## Feedback from JasPar to the IEEE 802.3bp Task Force regarding Draft 2.0

IEEE 802.3bp Interim Meeting September 2015

#### Item 1: Section 97.5.5.1.3 (p. 115, line 38-)

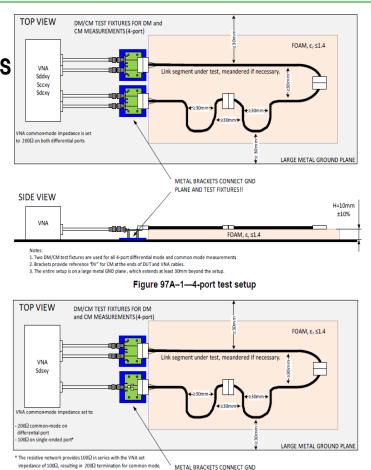
- D2.0 says that reference impedance is 100 Ω for all frequencies. (both type A and type B)
- **By** comparison, 802.3bw (100BASE-T1) and OPEN Alliance specification states  $100 \Omega + / -10\%$ .
- They also specify a rise time of 700ps.

- Question: Will 802.3bp specify a tolerance of the differential characteristic impedance value?
- Question: Will 802.3bp specify a rise time for measuring the impedance (e.g. 700ps)?
